**MONACO VILLA
EXTERIOR
REMEDiation**

2929 76th Ave SE, Mercer
Island, WA 98040

01/24/24
DESIGN COMMISSION

UPDATED DESIGN
USING COMMENTS

**ENLARGED AERIAL
VIEW**

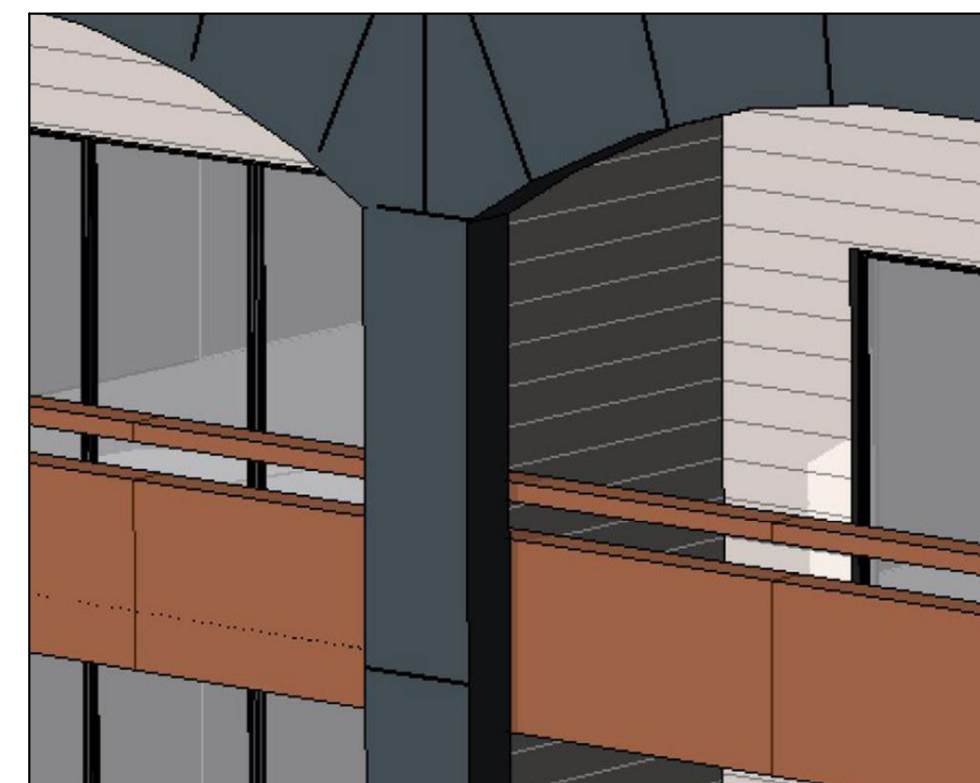
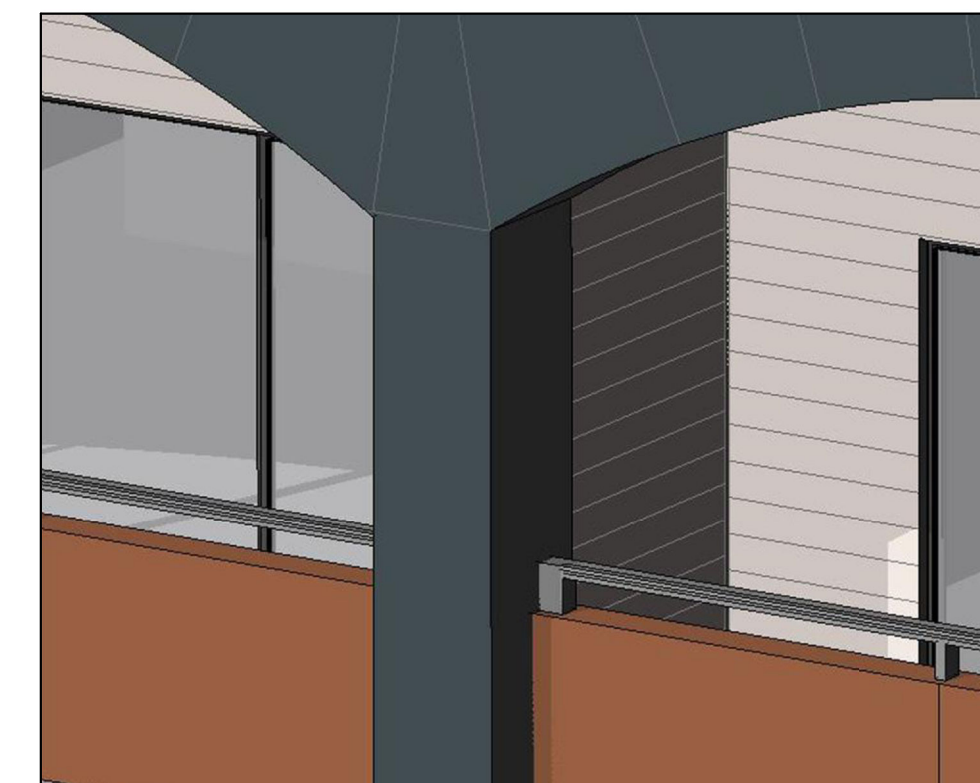
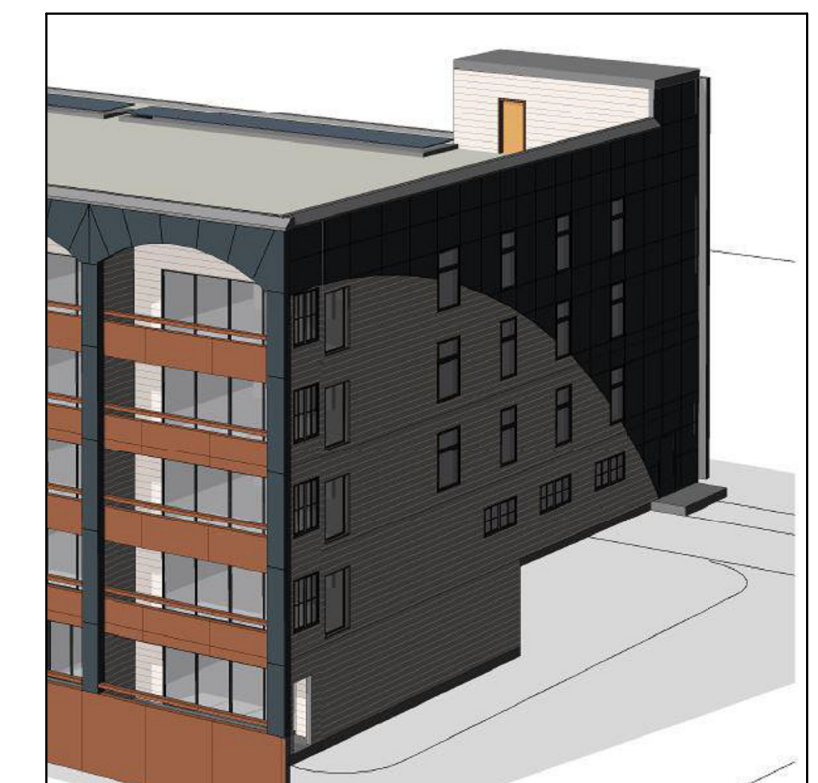
ORIGINAL ENTRY CANOPY WRAPPED
IN TRESPA

ORIGINAL COLUMN TREATMENT
APPEARED SOMEWHAT SHALLOW

ORIGINAL END FACADES TREATED IN A
SUPER GRAPHIC

UPDATED COLUMN TREATMENT READS AS
MUCH MORE SUBSTANTIAL

UPDATED ENTRY CANOPY
WRAPPED IN COPPER REUSED
FROM THE CURRENT BUILDING

UPDATED END FACADES
MIRROR EAST FACADE
RHYTHM AND SCALE
